September 26, 2024

Project No: 100200.32

**ADDENDUM NO. 4
TO THE CONTRACT DOCUMENTS AND DRAWINGS**

**For the construction of the
Aloe Bay Water Quality Enhancement Wastewater Treatment Facility**

SITE GROUNDING PLAN

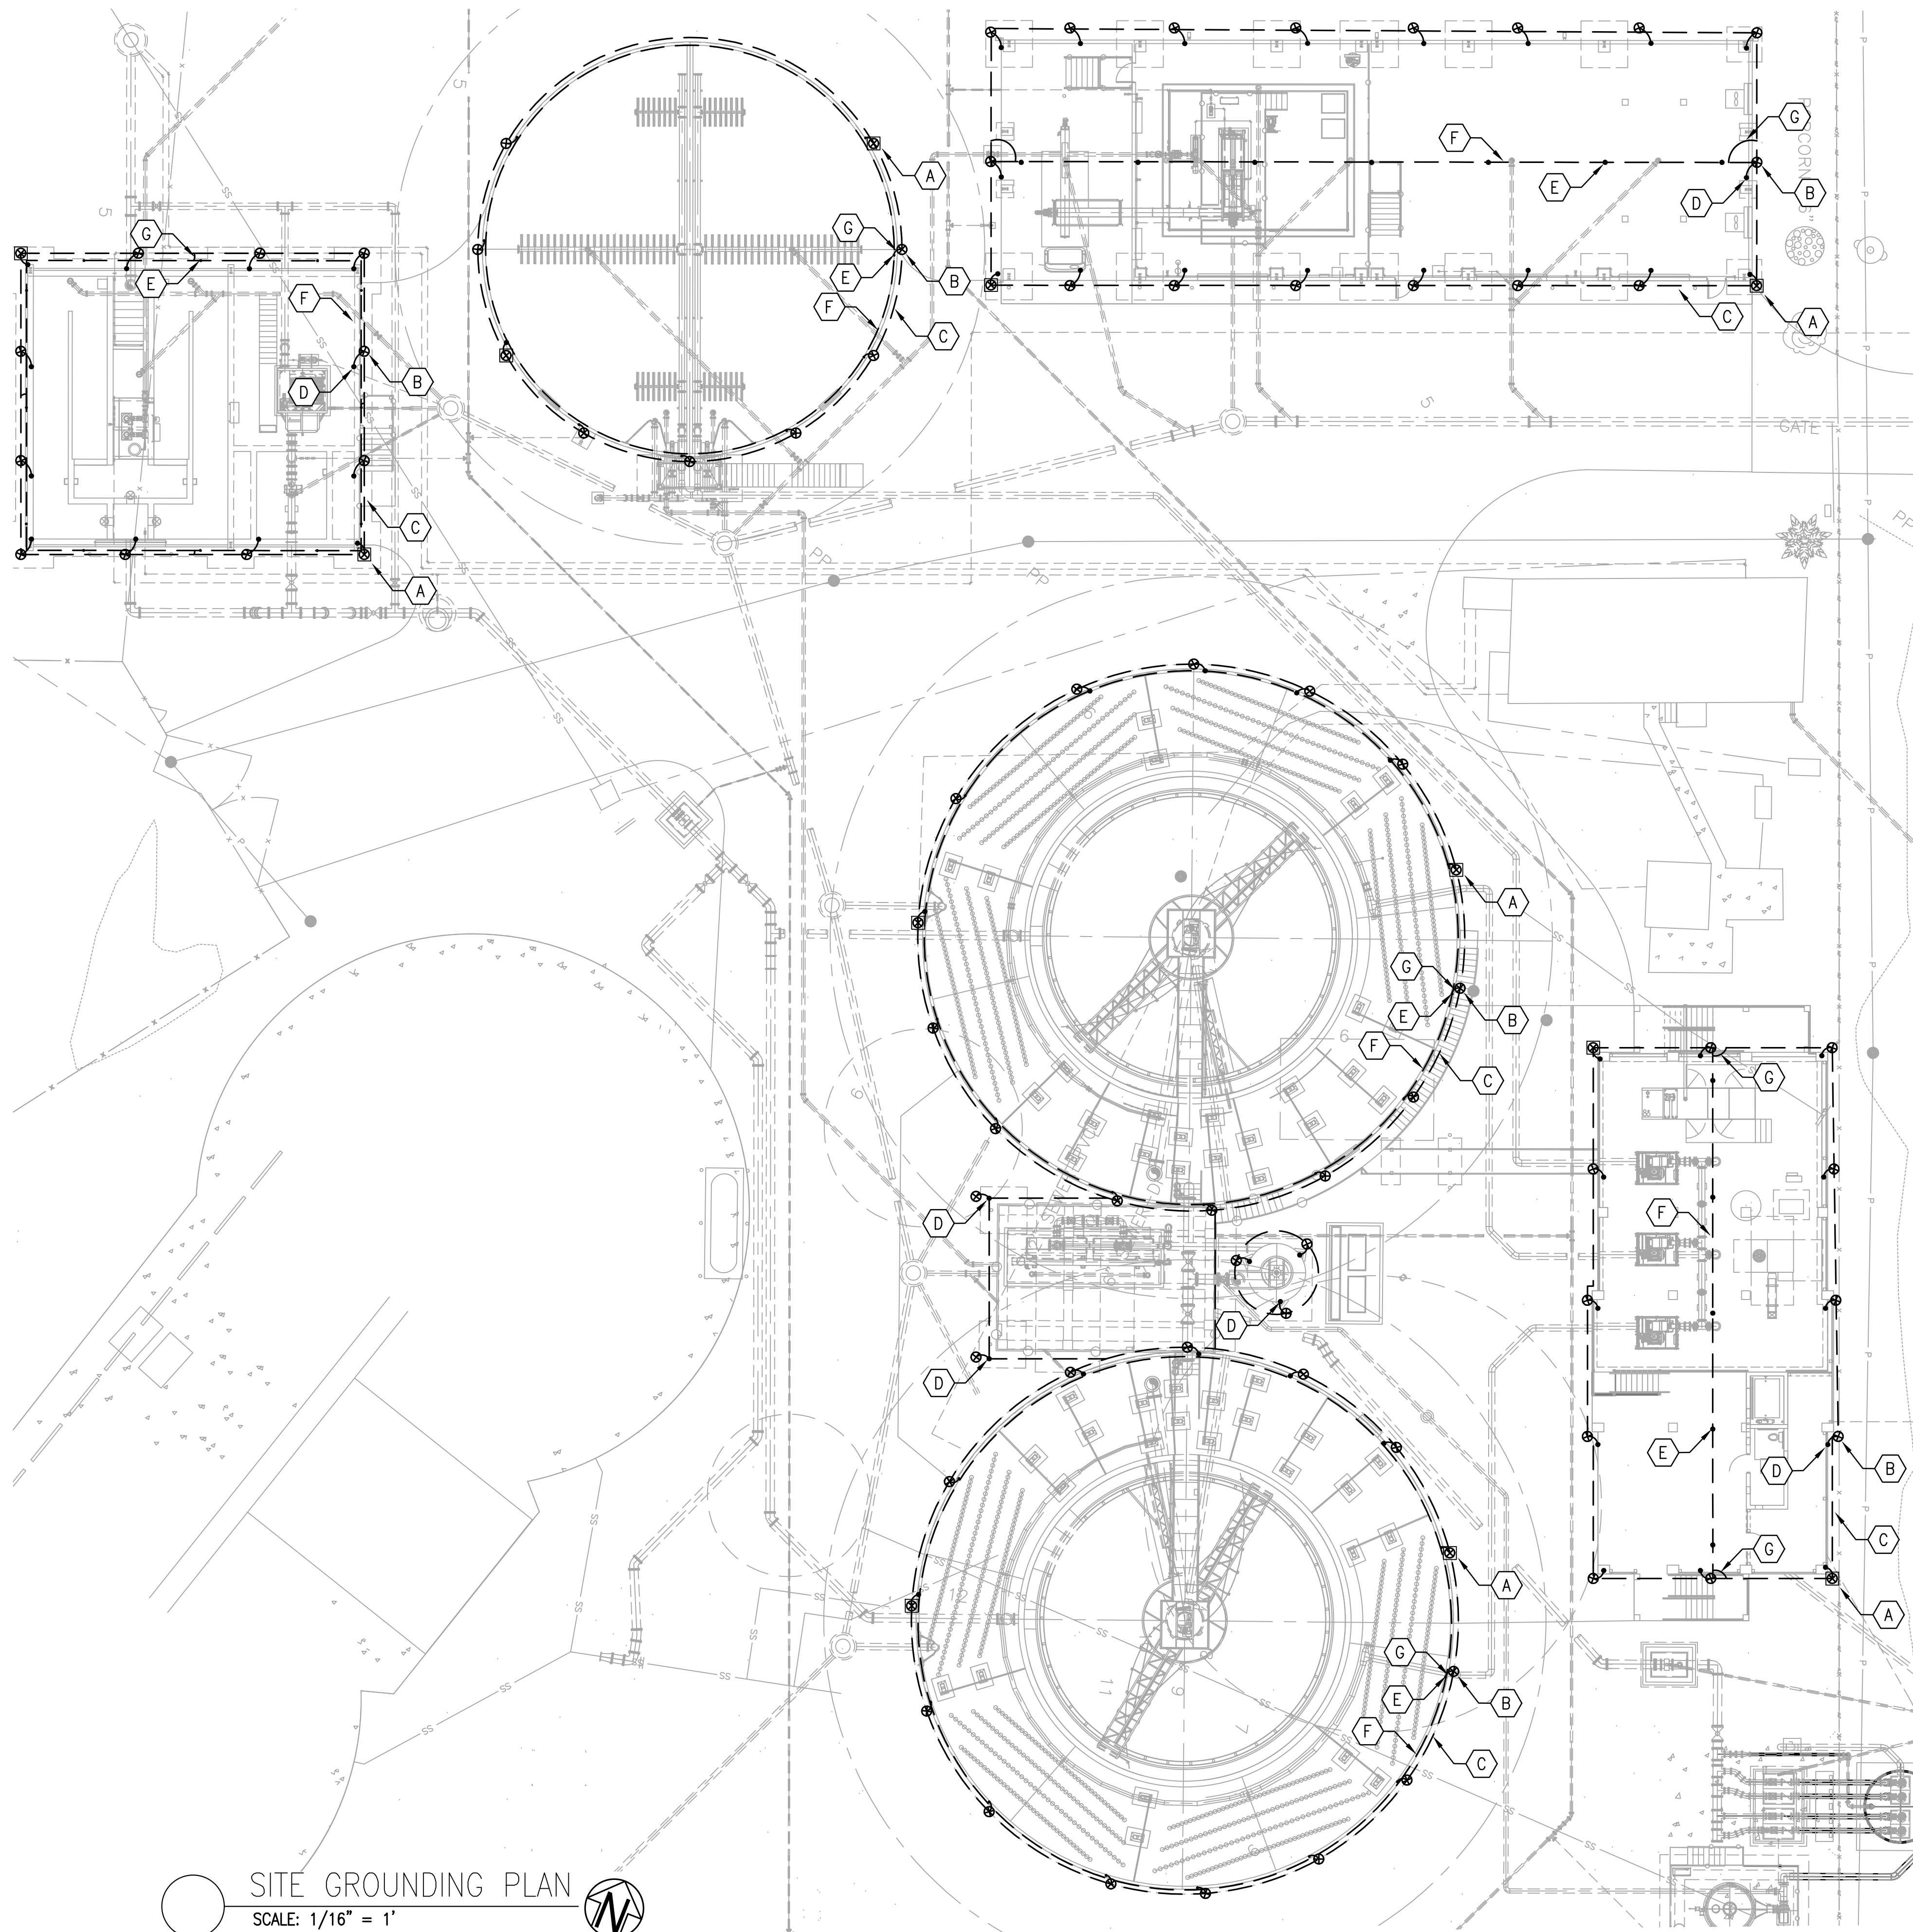
4. Plan sheet E-0.84 requires bonding structural rebar to ground ring. Bonding to any concrete encased tank steel is not recommended and shall not be allowed, per the tank manufacturer. All bonding shall be done by using air terminals on the top of the wall/dome with PVC conduit adhered to the exterior tank wall.

16. BONDING TO ANY CONCRETE ENCASED TANK STEEL (THE TWO PROCESS TANKS AND DIGESTER) IS NOT ALLOWED PER THE TANK MANUFACTURER. ALL LIGHTNING PROTECTION SHALL BE PROVIDED BY AIR TERMINALS ON TOP OF THE WALLS BONDED TO THE GROUNDING RING BELOW GRADE VIA DOWN CONDUCTORS ADHERED TO THE TANK WALLS IN PVC CONDUITS.

The electrical grounding, bonding, and lightning protection in association with the process basins, buildings, and plant structures have been updated as detailed on the attached drawing. Per the tank manufacturer and AWWA, bonding to concrete encased tank steel is not recommended or allowed. Therefore, the prestressed concrete tanks themselves (for the process basins and digester) shall not be bonded to the grounding ring. A separate lightning protection system shall be employed/installed after construction of the tanks using air terminals along the tank walls and down conductors secured to the tank exterior walls via PVC conduit that shall then be bonded to the grounding ring below grade around the tank structure (see associated addendum drawing).

FILE	SEE LEFT
VERIFY SCALE	
BAR IS ONE INCH ON ORIGINAL DRAWING	
DATE	AUGUST 2024
PROJ.	100200.32
DWG.	E-0.80

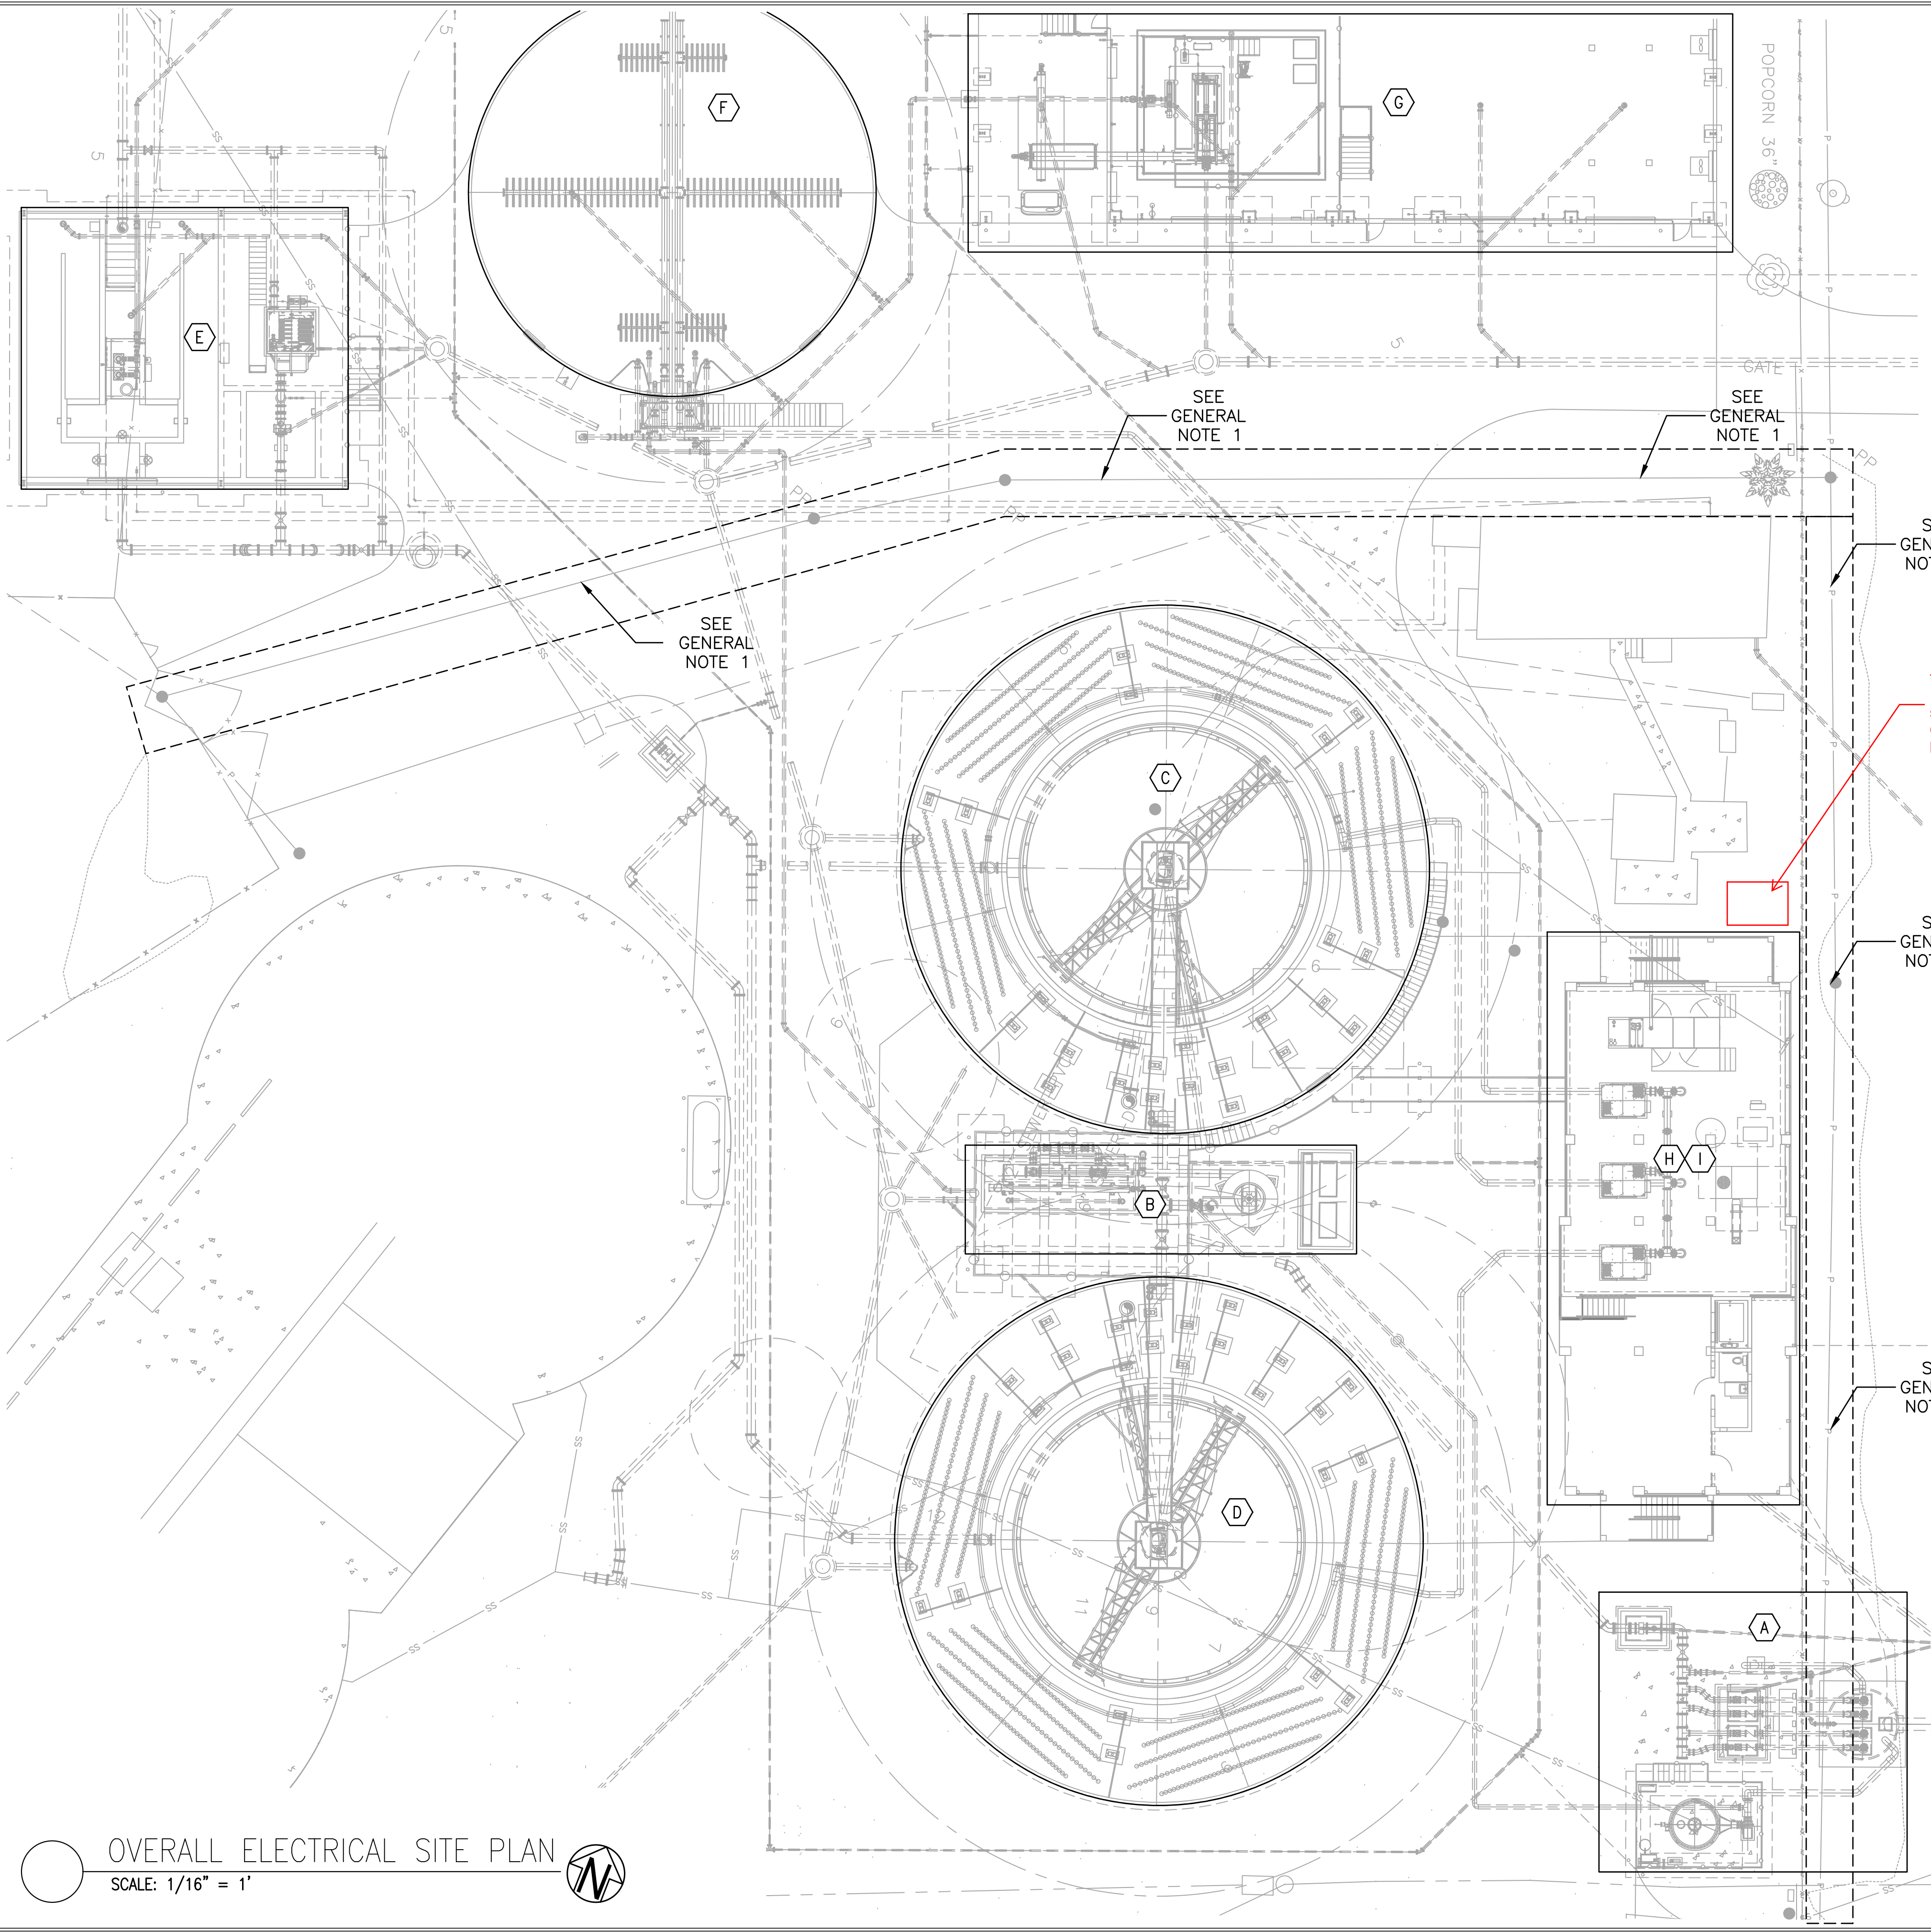
6. What is the proposed location for APCO transformer? Need to know this for the incoming feeds to the facility .

The proposed location for the APCO transformer is the northeast corner of the operations building. Refer to Sheet E-0.80 Markups.

FILE	SEE LEFT
	VERIFY SCALE
	BAR IS ONE INCH ON ORIGINAL DRAWING
	0  1"
DATE	AUGUST 2024
PROJ.	100200.32
DWG.	A-2.1

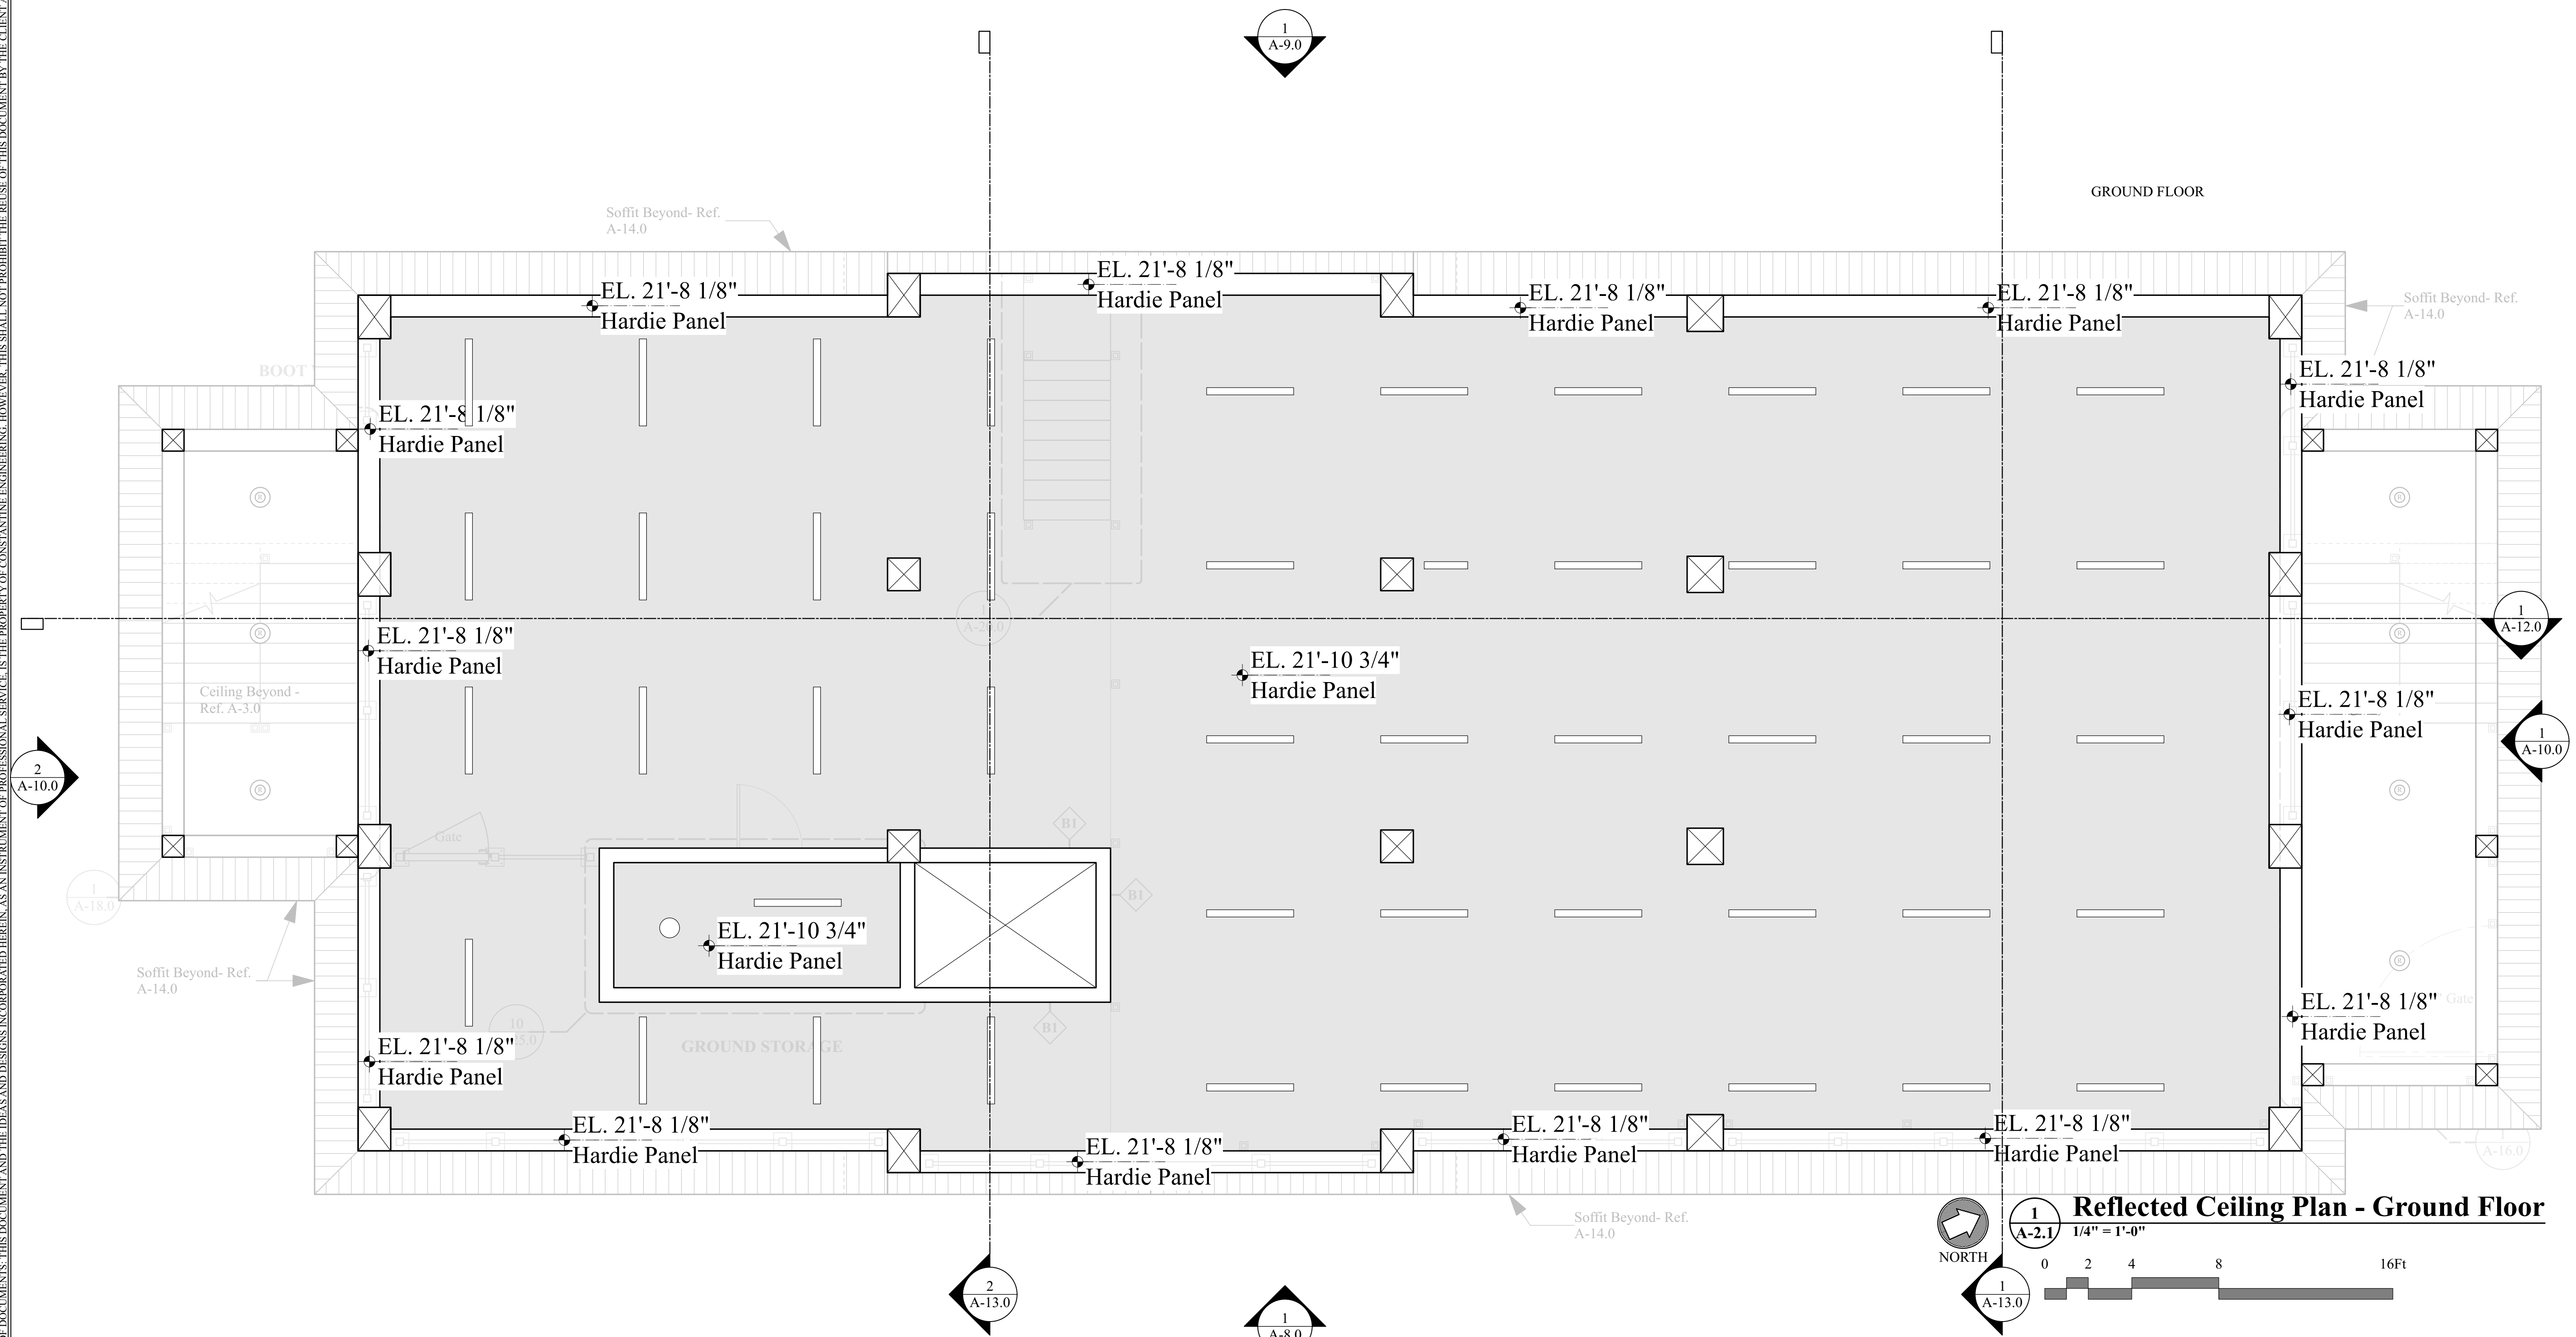
19. Detail 1- & 3-page A-14.0 indicates at bottom side of 2nd fl. structure, metal stud framing, there is no RCP for ground floor, what is the extent of the framing, how far down does it drop, what type framing members are necessary it appears to show 3-5/8" framing members dropping approx..

1. 6"-7" at 16oc, please clarify?

Refer to revised sheet A-2.1.
